THE CITY OF SAN DIEGO

ENVIRONMENTAL IMPACT REPORT

Project No. 360009
SCH No. 2014071065

SUBJECT: MERGE 56 (AKA MERGE 56 DEVELOPMENT PROJECT): The project is comprised of two project components, a mixed-use development and public roadway improvements. The Mixed Use Development Component would require a GENERAL PLAN AMENDMENT from Commercial Employment, Retail and Services; Residential; and Parks, Open Space and Recreation to Multiple Use; a COMMUNITY PLAN AMENDMENT (CPA) to redesignate the site from Commercial Regional (CR) and Medium High Density Residential to Local Mixed Use (LMXU) within the Torrey Highlands Subarea Plan; a REZONE from Regional Commercial (CR-2-1) and Multi-family Residential (RM-3-9) to Community Commercial (CC-3-5) and Residential Small Lot (RX-1-2); a PLANNED DEVELOPMENT PERMIT (PDP) to amend PDP No. 53203; a SITE DEVELOPMENT PERMIT (SDP) to amend SDP No. 53204; a CONDITIONAL USE PERMIT (CUP) to allow a cinema/theater greater than 5,000 square feet in size; and a VESTING TENTATIVE MAP (VTM) to amend VTM No. 7938 to resubdivide from 3 lots to ~~400~~ 107 lots (84 Residential Small Lot zoned lots, ~~seven~~ 12 Community Commercial zoned lots, ~~five~~ seven

Figure 5.3-1b

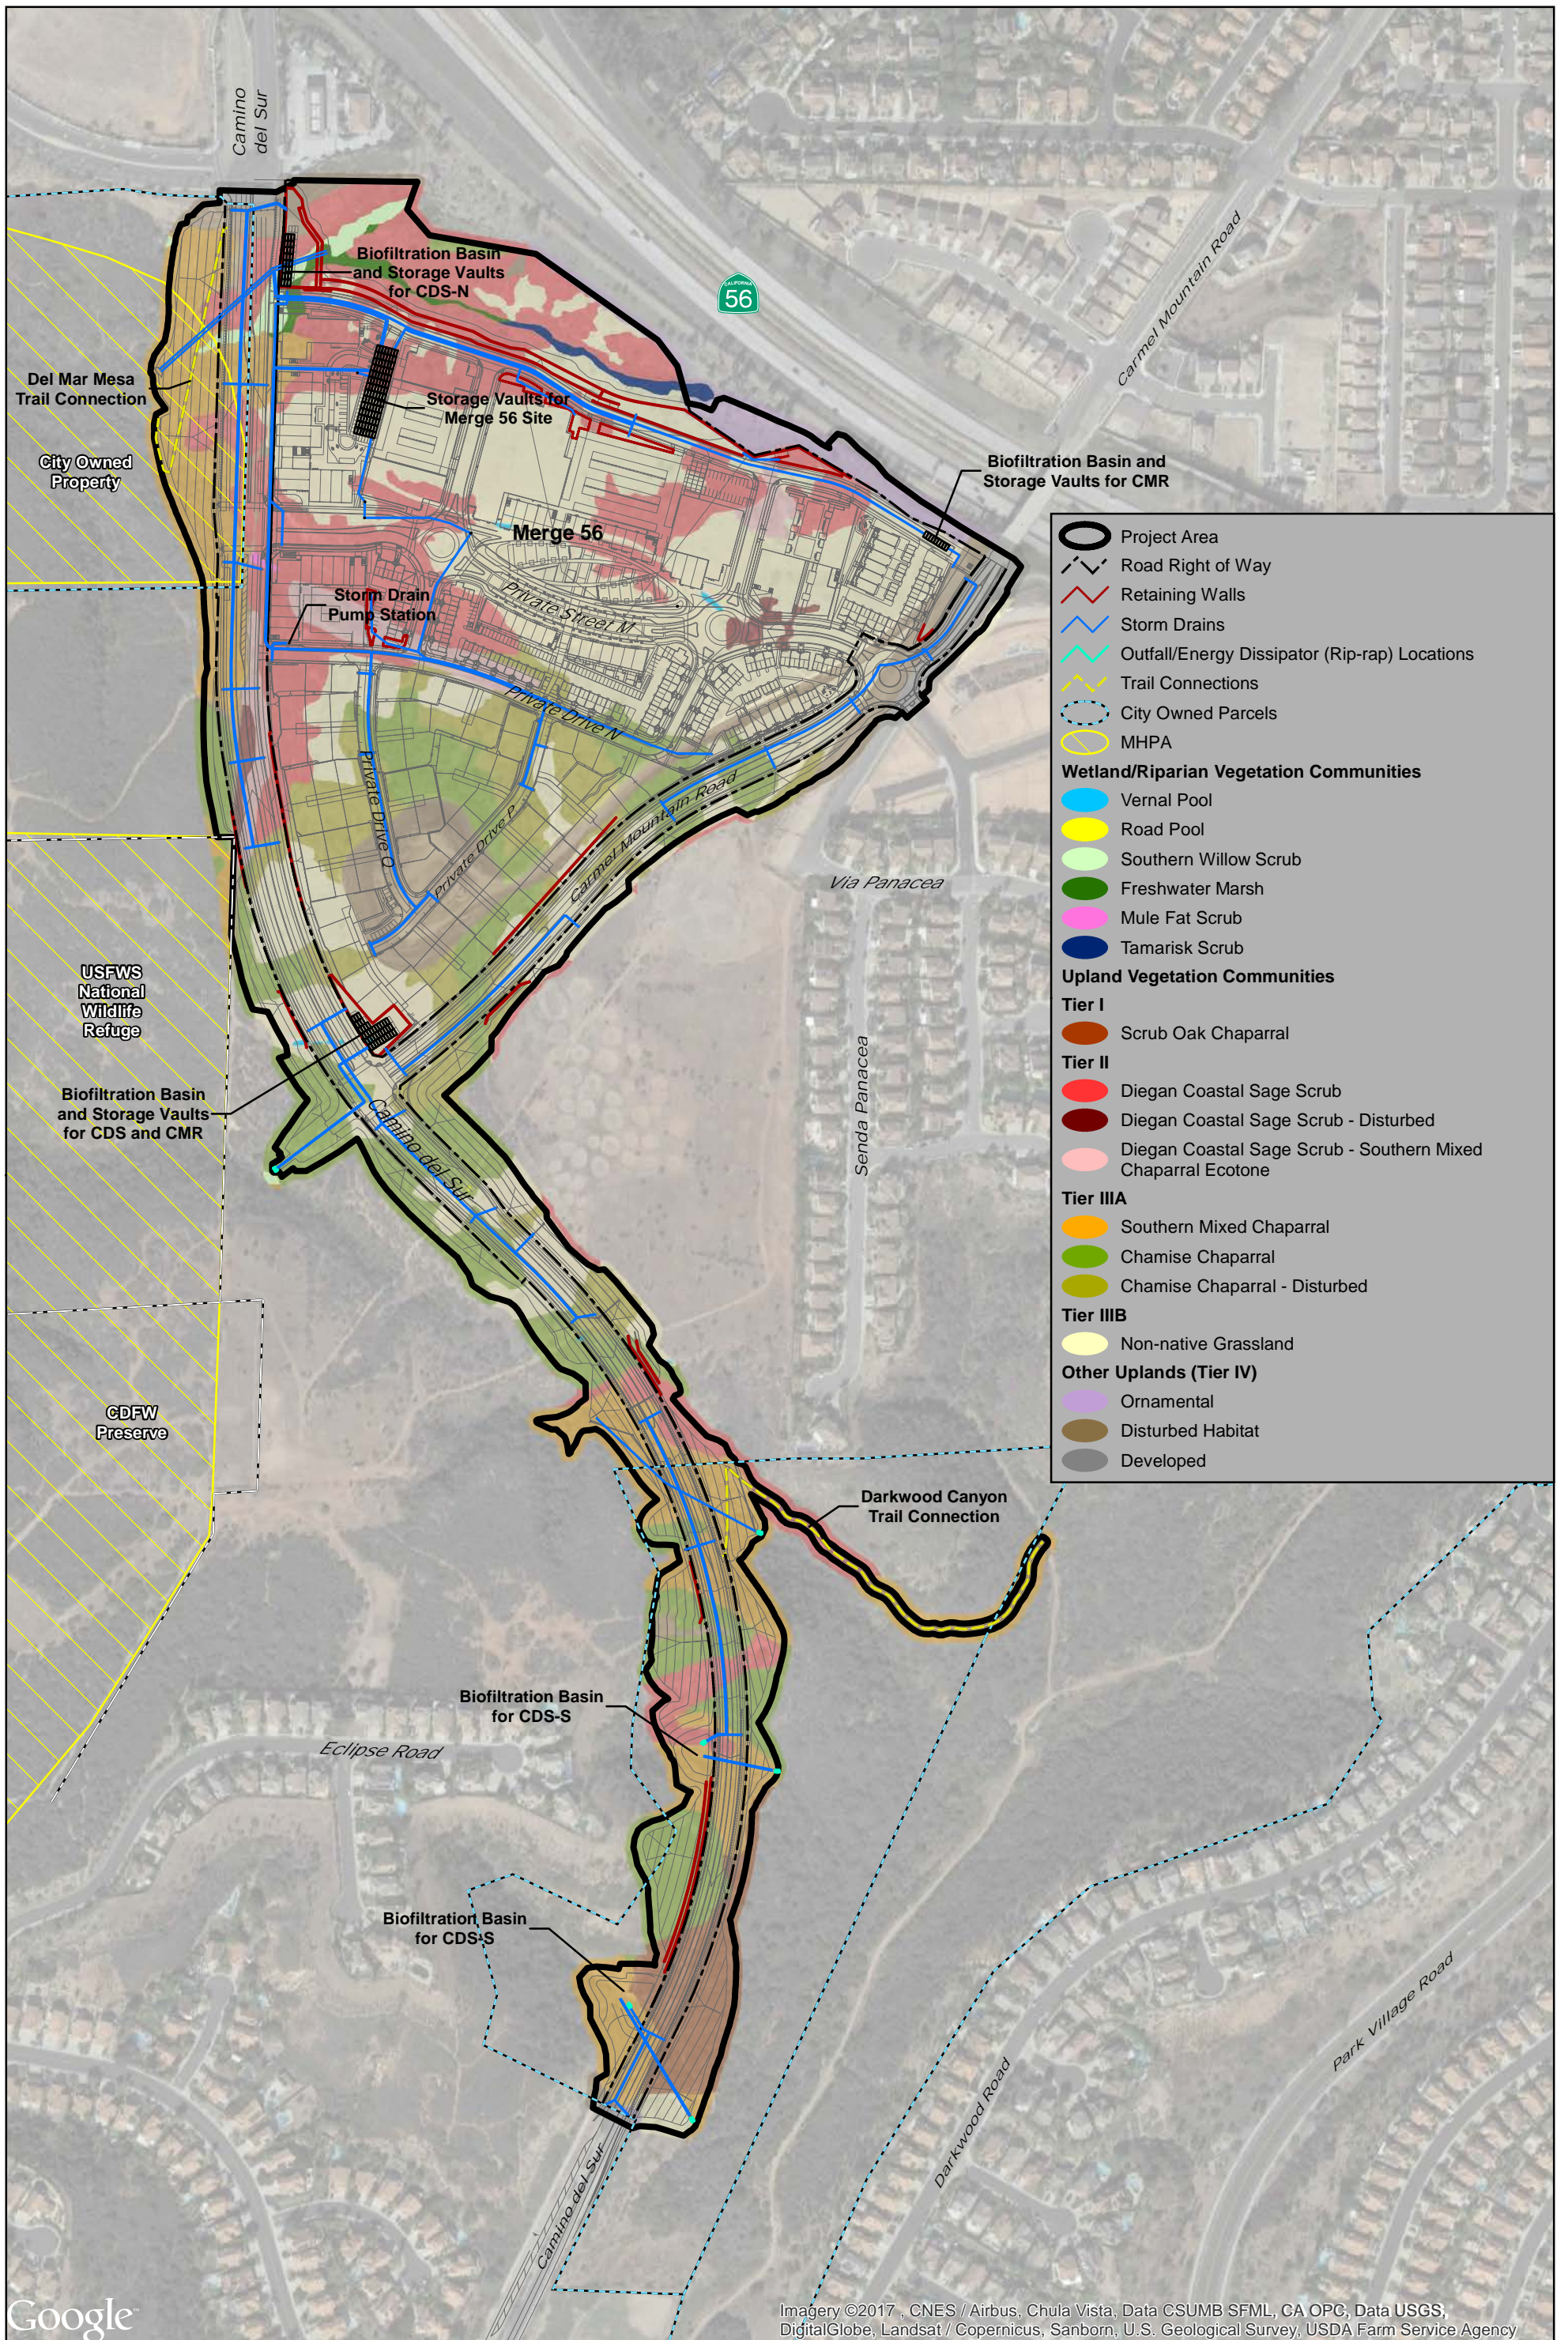
- N4 4. We request that figures 3-11, 3-12, and 5.3-1b clearly show all of the grading within the roadways. The grading of the roadways directly correlates to the approved VTM for the Rhodes Crossing Project and a clear depiction of the grading is necessary for an accurate analysis of the DEIR for Merge 56. Specifically, we request an exhibit that clearly illustrates that Merge 56 is still planning to grade the roadways in their entirety according to the 4 lane design so as no new gaps are created between the 2 lane roadway design, and the approved boundary for the Rhodes Crossing VTM.

- N2 The MHPA line shown on Figures 2-2 and 3-3 for an off-site parcel (Rhodes Crossing Lot 8). has been updated to show the corrected alignment on the following figures in the Final EIR: Figures 2-2, 3-11, 5.1-1, 5.1-2, 5.3-1a/b, and 5.3-3. These revisions do not alter the analysis or conclusions disclosed in the Draft EIR.

Figure 5.3-3

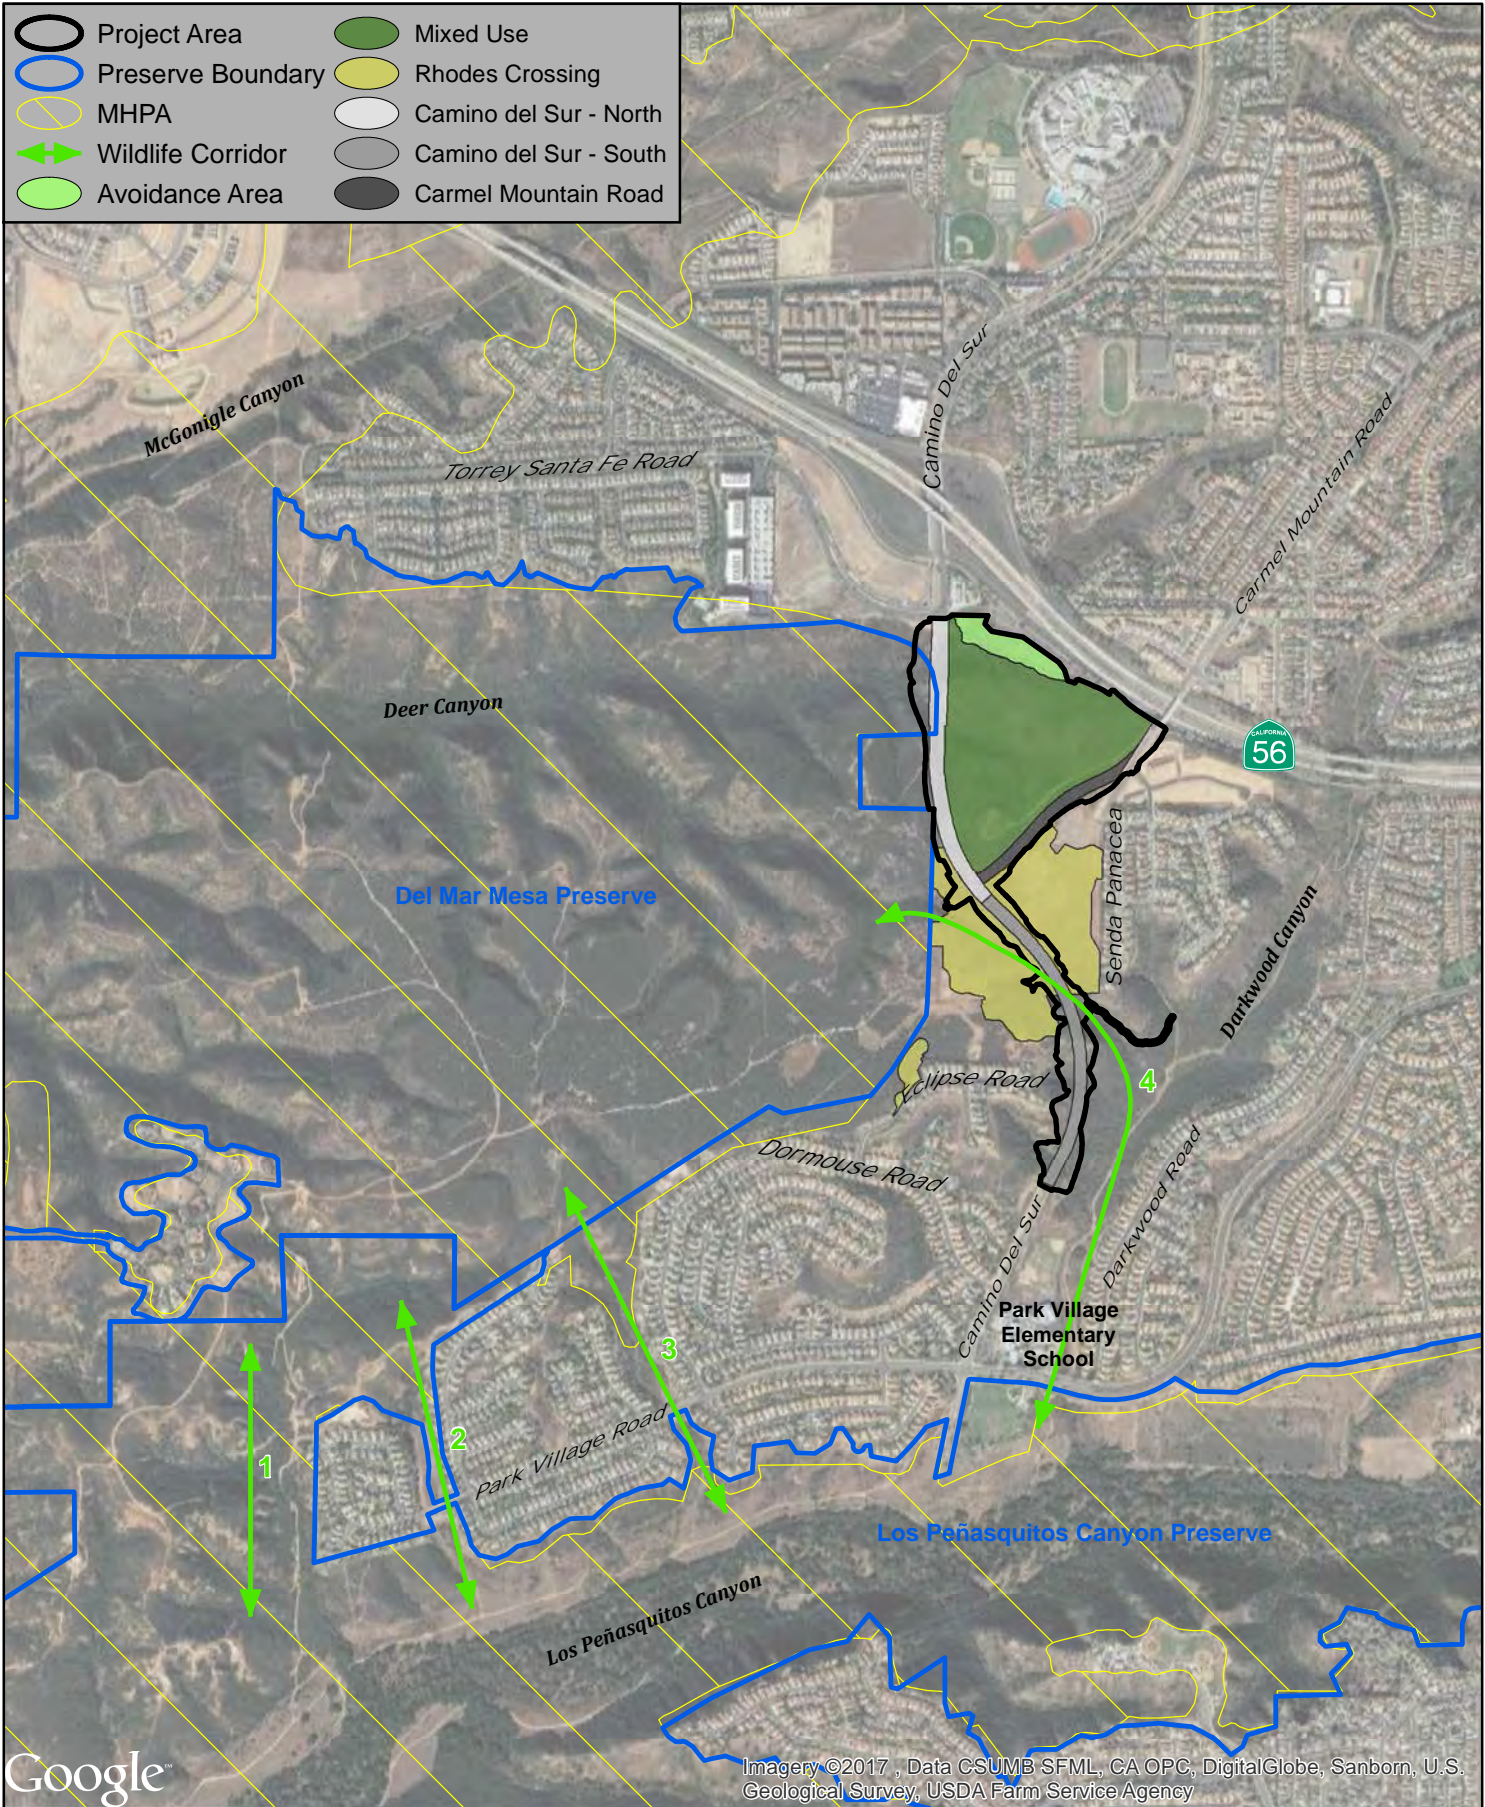
- N3 The Draft EIR conceptually depicts the wildlife corridor between Darkwood Canyon and Del Mar Mesa Preserve on Figure 5.3-3. The green line referenced in this comment was taken from existing, previously mapped corridor data contained in the City's Del Mar Mesa/Carmel Mountain Natural Resource Management Plan. (Figure 3-5; City 2015) and does not reflect any new wildlife corridor locations nor does the depiction alter any prior approvals that show the corridor with greater precision. As such, no changes were made to the figure in response to this comment.

There are four wildlife corridors connecting Los Peñasquitos Canyon and Del Mar Mesa recognized in the Del Mar Mesa Natural Resource Management Plan, as presented in Figure 3-5 in that plan and reproduced in Figure 5.3-3 of the Draft EIR. As noted by the commenter, wildlife movement between Del Mar Mesa and Los Peñasquitos Canyon Preserve is constrained due to existing development. The proposed alignment and roadbed design for Camino Del Sur in Darkwood Canyon includes a narrower road and an at-grade area where wildlife crossing could occur. This section of roadway also incorporates traffic calming measures and median landscaping designed to be non-attractive to wildlife. Given the limited viability of the Darkwood Canyon connection outside of the MHPA, now and over the long term independent of the project, the revised design of Camino Del Sur considered in the Draft EIR, and the presence of the three higher quality connections to the west that are conserved in the MHPA, the project would not interfere substantially (i.e., would not have a significant impact) on the regional movement of wildlife. Refer to response to comment J13 which further describes why the project's impacts to wildlife movement would be less than significant and are adequately addressed in the Draft EIR.
